**DEVELOPMENT REVIEW BOARD sketch plan hearing scheduled for May 8, 2024 @ 8:00 pm**

<b>General Information</b>	
Applicants:	George and Claire Aube Consultant: Jason Barnard, Barnard and Gervais
Application No.: <b>DRB 24-044-SK</b>	Parcel ID: 00014-1052
Status of Applicant:	Owner
Requested Action:	Sketch Plan Review Two-Lot Subdivision
Purpose:	Classify Subdivision
Zoning:	Rural District, Conservation District
Location:	1052 Carpenter Road and 1814 Dorset Street
Size:	100 +/- acres
Existing Land Use:	Residential lots, agriculture
Surrounding Land Uses:	Residential and agriculture
Permitting / Subdivision History:	<p><b>1052 Carpenter Road (Lot 1) – Parent Parcel</b>                      89-25-GD: Single-family residence permit (replaced former residence)                      1995: Planning Commission approved creation of a 10 +/- acre lot around the Aube residence, resulting in a 90-acre lot for agriculture to the south, as well as a 5.02-acre lot on the north side of Carpenter Road.                      PC-13-19-SD: created a 5.71-acre lot at 1732 Dorset Street                      PC-15-10: created a 5.07-acre lot at 1450 Dorset Street                      2002: agricultural ex

*Purple highlights show areas of steep slopes.*

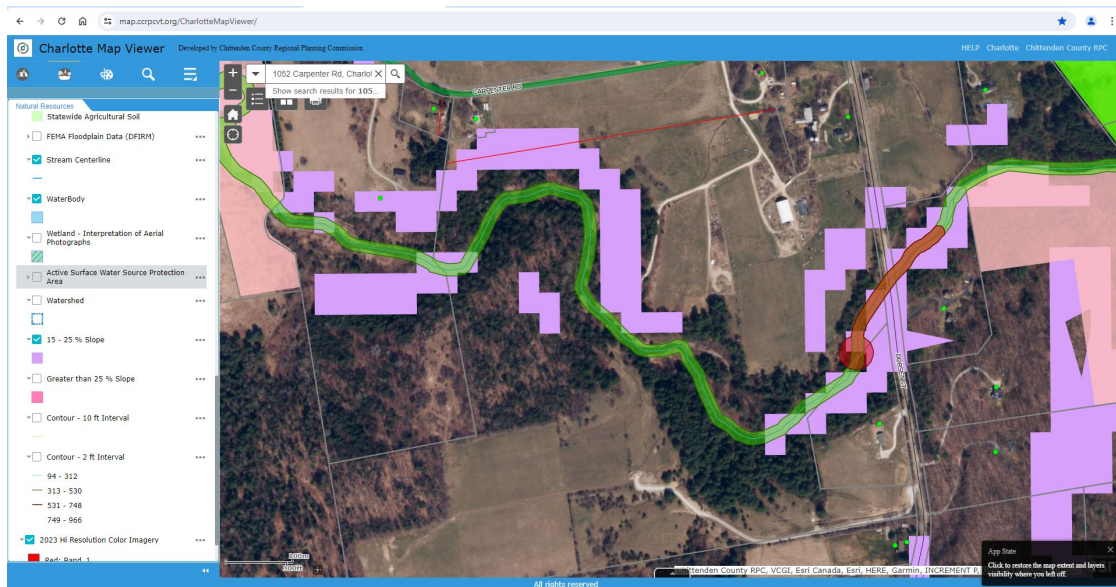
- a. Land in active agricultural use – the parent parcel is enrolled in Current Use for agriculture and forestry.
- b. Primary Agricultural Soils (Prime and Statewide) – pockets of prime ag soil exist, but much of the farm is statewide agricultural soil.
- c. Steep slopes (>=15%) – areas along the LaPlatte River and the forested area on the western side of the property contain slopes in excess of 15% grade.
